#### CITY OF SACRAMENTO

SUBJECT:

LOCATION: Southeast Corner of Stockton Boulevard and 48th Avenue

#### CITY PLANNING COMMISSION

VICINITY - LAND USE - ZONING

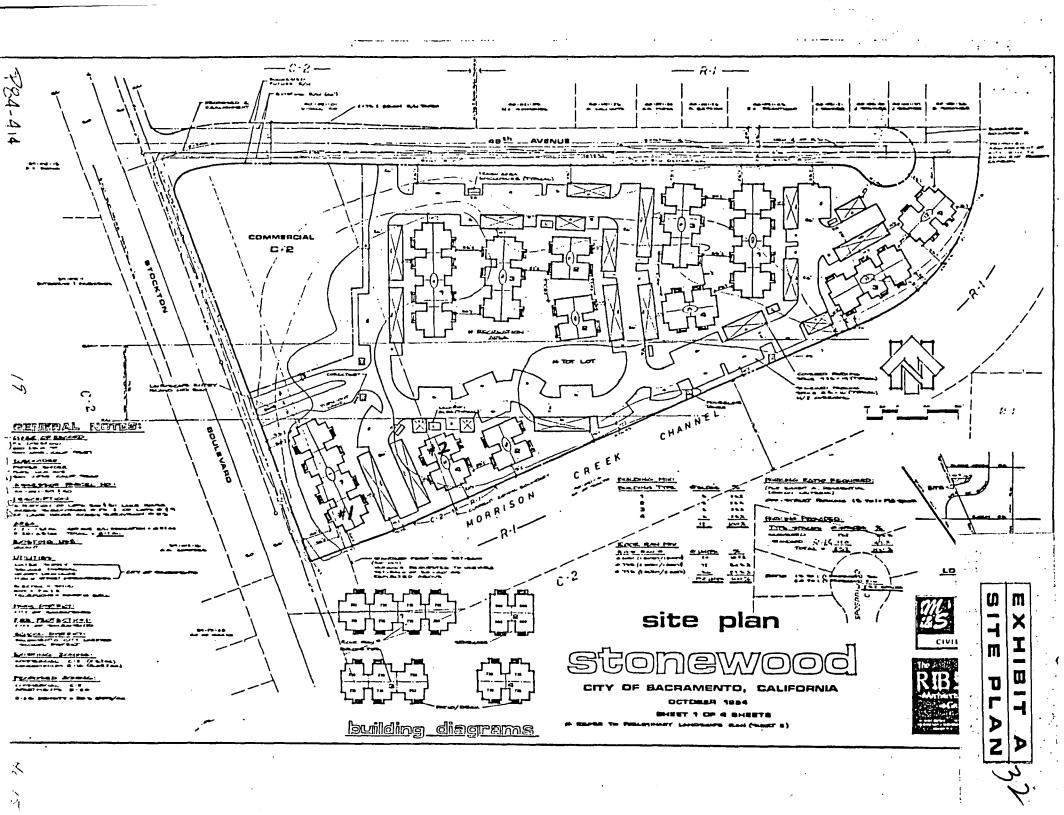
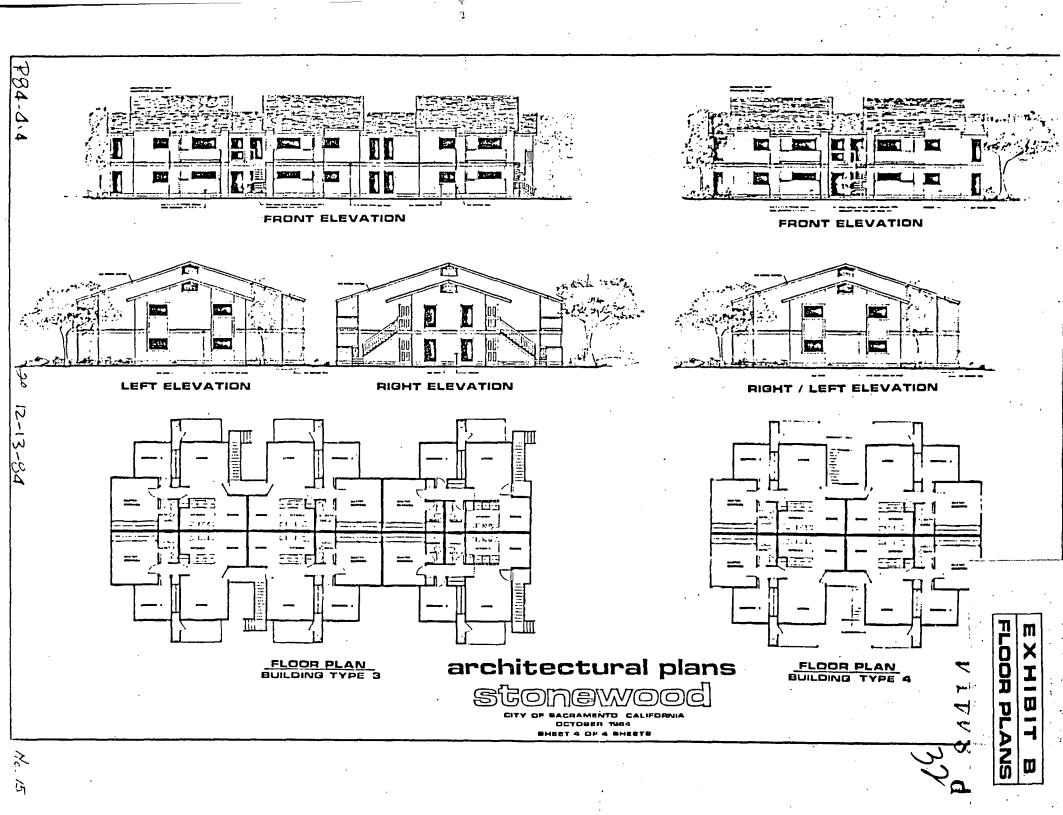
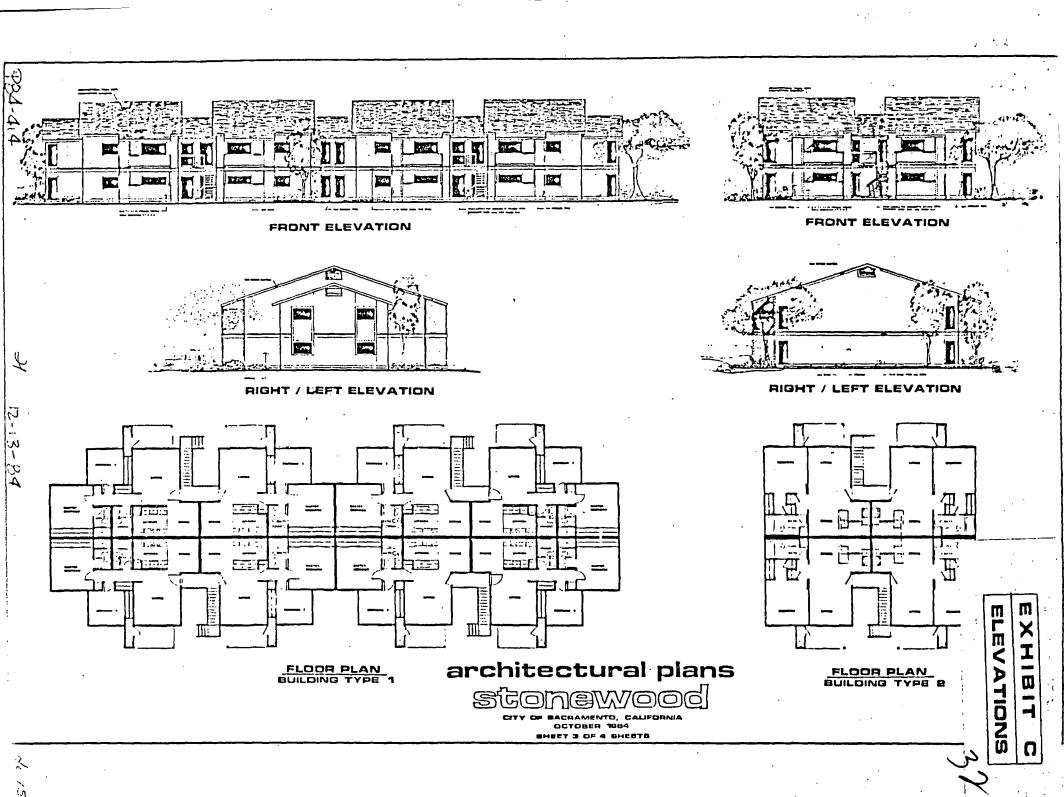
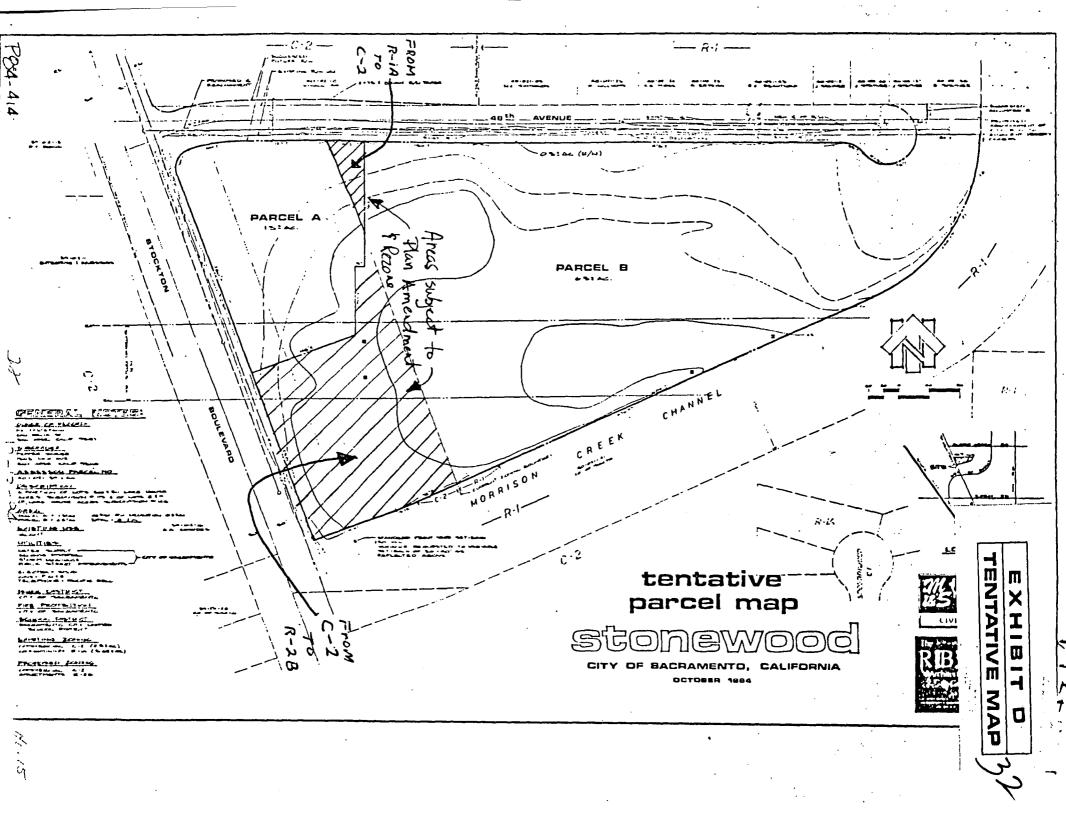
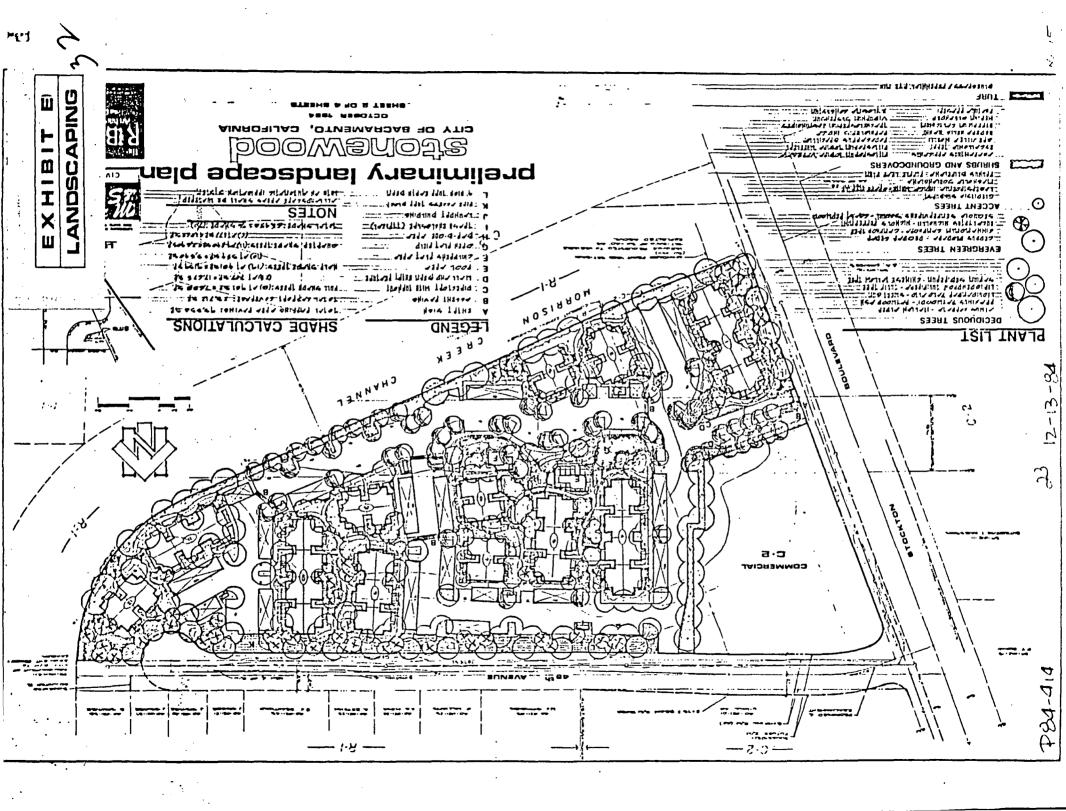
- A. The subject site consists of two irregular shaped parcels which are bisected by a 100-foot wide powerline easement and which are adjacent to the Morrison Creek Drainage Channel to the south and east.

- B. The applicant's plans indicate a mixture of one bedroom-one bath; two-bedroom-one bath and two-bedroom-two bath units ranging in size from approximately 600-800 square feet. Both covered and uncovered parking spaces will be provided. The exterior building materials will be a combination of wood siding (T1-111) and stucco with thick butt compostion roof shingles. Staff notes that a recreation area with swimming pool and a tot lot are included in the proposed project. In addition, it is recommended that bicycle storage areas and trash enclosures be constructed which are in compliance with the standards set forth in Exhibit F.

- C. The site plan indicates a variable setback ranging from 30-40 feet along Stockton Boulevard. A 50-foot setback is presently required. Staff requests that a minimum 35-foot setback be maintained along Stockton Boulevard which can be achieved by locating the carports and buildings one and two five feet to the east. The applicant's plans indicate that the setback area along 48th Avenue and Stockton Boulevard will be intensely landscaped, including a four-foot high berm. Staff also requests that the applicant provide a solid six-foot high decorative masonry wall adjacent to the commercially-zoned parcel.

1. Divided entry on Stockton Boulevard is not acceptable design. A single 35-foot driveway is more appropriate and usable by large service/delivery vehicles and moving vans. If a divided driveway is insisted upon, the entrance will be 25 feet wide and the divider will be 16 feet wide continuing to the sidewalk without the large radius. The edge of the driveways will be no less than 10 feet from the side property line measured at top of the curb.

- Proposed abandonment of 48th Avenue will leave Parcel 040-021-38 without
  access unless this developer deeds his half to the north side. A better
  solution would be to extend the cul-de-sac 40 feet eastward, or merge parcels 040-03
- E. The cul-de-sac at the end of 48th Avenue should be extended to permit a better circulation pattern. This will require that a portion of the existing street right-of-way will need to be abandoned. Staff recommends that the applicant proceed with the abandonment and coordinate, future street dedications with the Traffic Engineering Division.
- F. Staff suggests that the portion of the subject site being rezoned to Garden Apartment (R-2B) include an 'R' Review requirement. In the event ahat the applicant should modify his plan, staff and the Commission would have the opportunity to review the modifications for compliance with City standards.

A minimum 35 foot setback shall be maintained along Stockton Boulevard.
